METROPOLITAN GOVERNMENT OF NASHVILLE AND DAVIDSON COUNTY

STAFF RECOMMENDATION
1801-1803 5th Avenue North
March 17, 2021

Application: New Construction—Infill (Part I SP)
District: Salemtn Neighborhood Conservation Zoning Overlay
Council District: 19
Base Zoning: R6-A
Map and Parcel Number: 08108025300
Applicant: Jeff Zeitlin, Developer
Project Lead: Sean Alexander, sean.alexander@nashville.gov

SITE PLAN

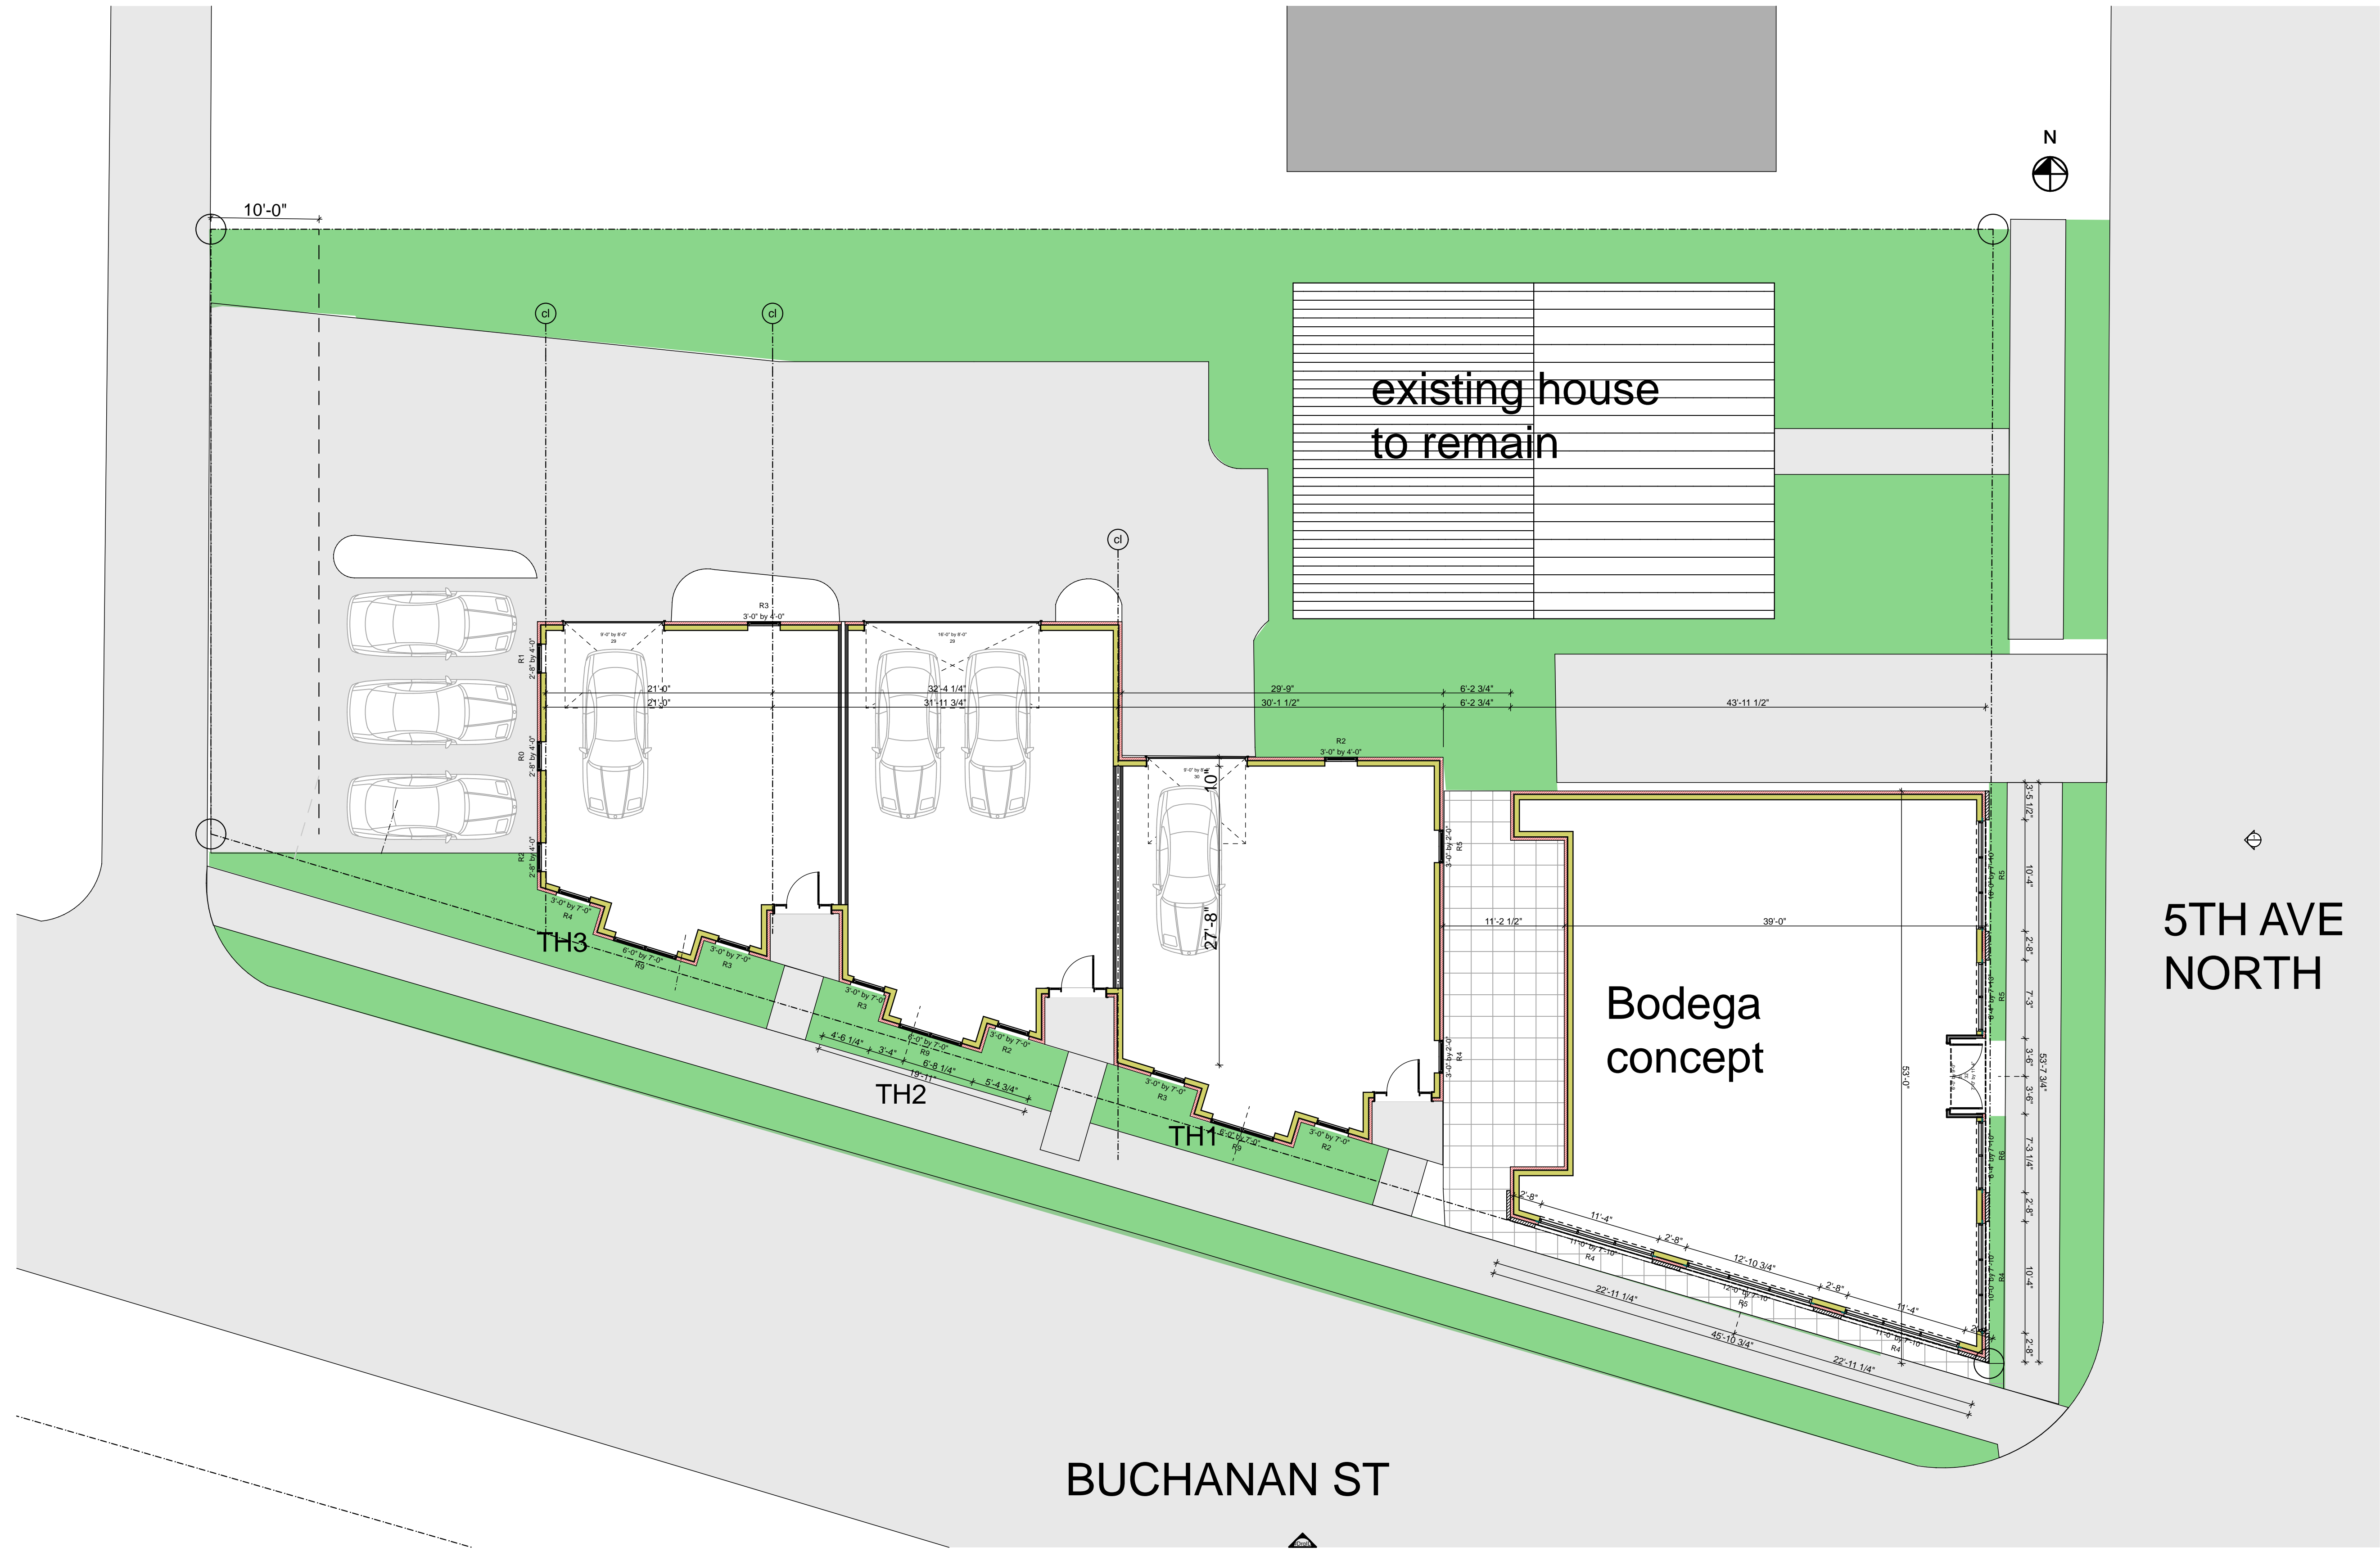
Setback & Rhythm of Spacing: The corner commercial building will be built with an eleven foot, six inch (11'-6") setback from the edge of 5th Avenue and a fourteen foot (14') setback from Buchanan Street, after providing for required curbs, buffers, sidewalks, and a right-of-way dedication. The townhouses will have a fourteen foot (14') setback from Buchanan Street, and a twenty foot (20') setback from the alley to the west. The setback from the north property line to the townhouses is thirty-four feet (34') and the townhouses will be separated from the commercial building by six feet (6') and from the existing contributing house by ten feet, six inches (10'-6").

The setbacks of the commercial building are typical of historic corner commercial forms. The setbacks of the townhouse component are more comparable to commercial building types than the residential building types typical of Salemtown. However, staff finds that because this development is near the edge of the overlay where the context and history are a combination of residential and commercial, Staff finds that these setbacks are appropriate

Staff finds that the project meets section III.C of the design guidelines.

ELEVATIONS N,S

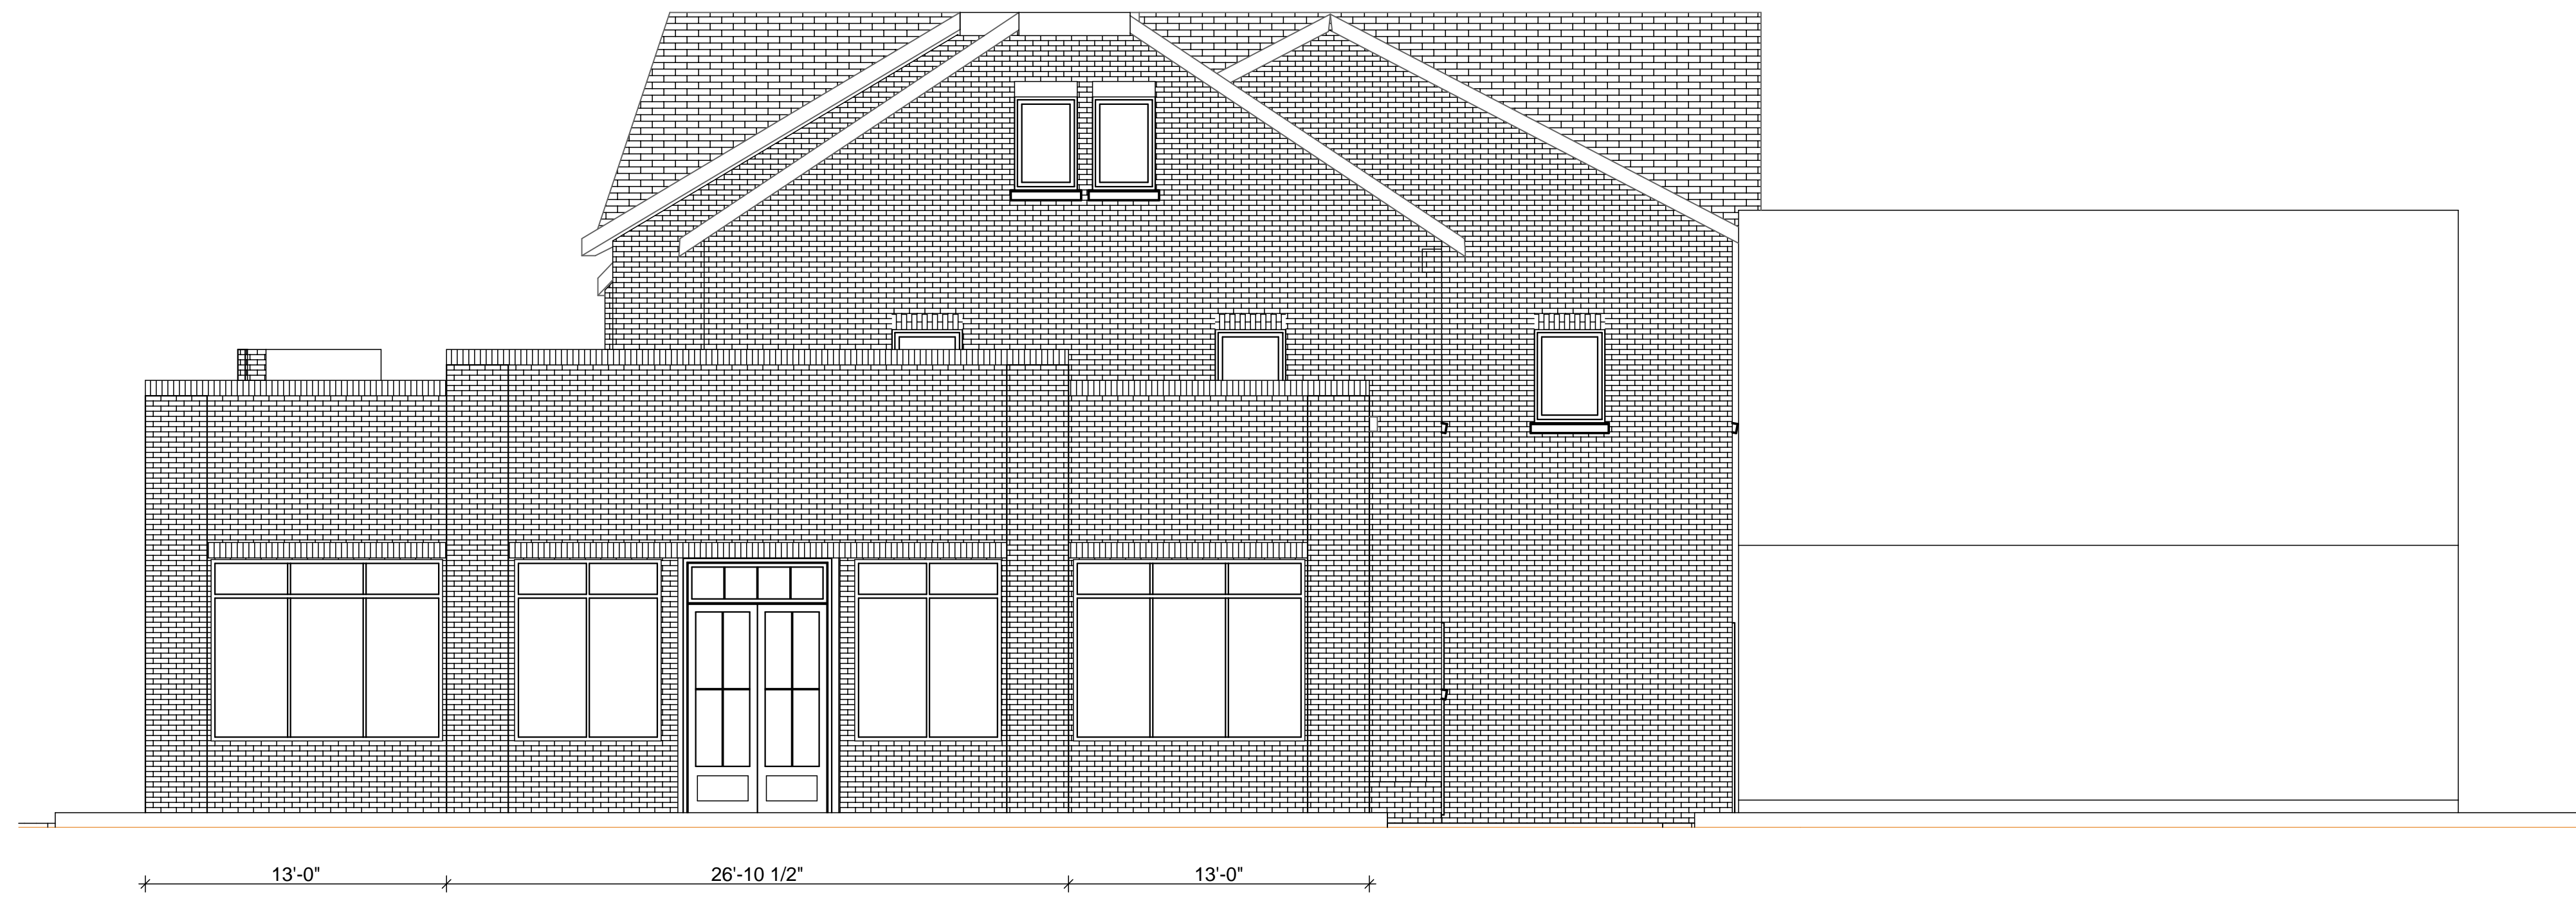
The townhouse building will comprise three units, with a total frontage of eighty-eight feet (88') on Buchanan Street. The three units will each have a two-and-one-half-story form with a front-facing gable with an eave height of twenty-five feet (25') and a ridge height of thirty-five feet (35'). The guidelines for Salemtown specify that infill may be thirty-five feet (35') tall. The majority surviving historic houses in the district are one-story or one-and-one-half-story, but the context historically did include several two-story houses. There were no two-and-one-half-story houses in the neighborhood historically. A previous proposal that would have constructed a two-and-one-half-story structure on 4th Avenue South was approved by the Commission with the condition that the upper half-story was eliminated.

The proposal meets the maximum height permitted by the design guidelines, but Staff finds that the upper half-story is not compatible with the historic context.

The townhouses will have cross-gabled roofs, connecting them on their shared interior walls, with gables projecting to the front and to the right (east). The gabled roofs have a pitch of 11/12. The gabled forms and pitches are compatible with the roofs of historic buildings in the neighborhood; however, the proposed townhouses are two and-one-half-stories whereas the guidelines permit infill to be up to two-stories.

With a condition that the form of the townhouse building is revised to be two-stories and return to MHZC before proceeding to the Planning Commission, Staff finds that the height and scale of the proposal is appropriate and that it meets sections III.A and III.B. of the design guidelines.

Staff recommends that the townhouses be revised to be two-stories and return to the Historic Zoning Commission for approval before proceeding to the Planning Commission, Staff finds that the proposal meets Section II.B of the design guidelines.

1. The townhouses are revised to be two stories and return to the Historic Zoning Commission for approval before proceeding to the Planning Commission; and
2. The applicant return to the Commission with the final approval of the design, materials, window/door placement, and all utilities, mechanicals, and other appurtenances if the SP is approved by Metro Council;
